# Pioneer Casual Wear Ltd. (9869)

# Identified Priority 1 Concerns

## 1<sup>st</sup> Priority 3 Concern

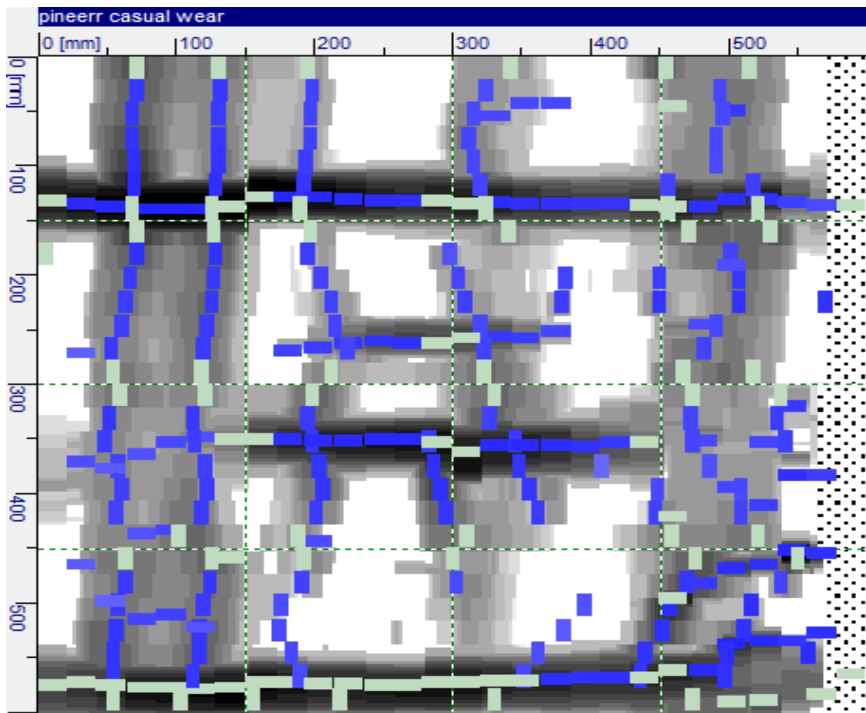
There are a lot of cracks appearing on the Ground Floor beams and slabs in Block A. The cracks occur at the mid-span of beam and slab. The cracks need to be investigated to determine the width and depth to find the appropriate remedial solution for the crack.

In the meantime, the loading on the Ground Floor slab should be carefully monitored to ensure no overloading occurs

We require that these items be investigated in a Detailed Engineering Assessment

## 2<sup>nd</sup> Priority 3 Concern

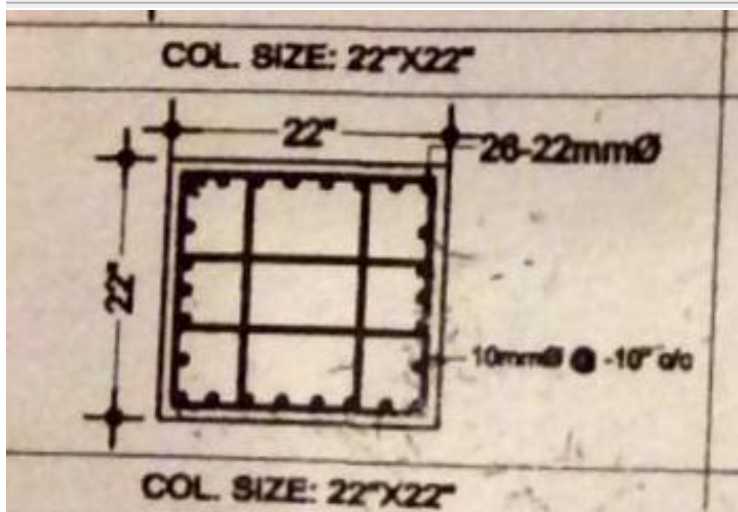
The ferroskan shows that the number of rebars in column C3 does not match with the structural drawings. It appears that the number of bars is less.

A Detailed Engineering Assessment should be carried out to find out the actual as-built condition of the columns and the structural calculations checked for sufficient structural capacity
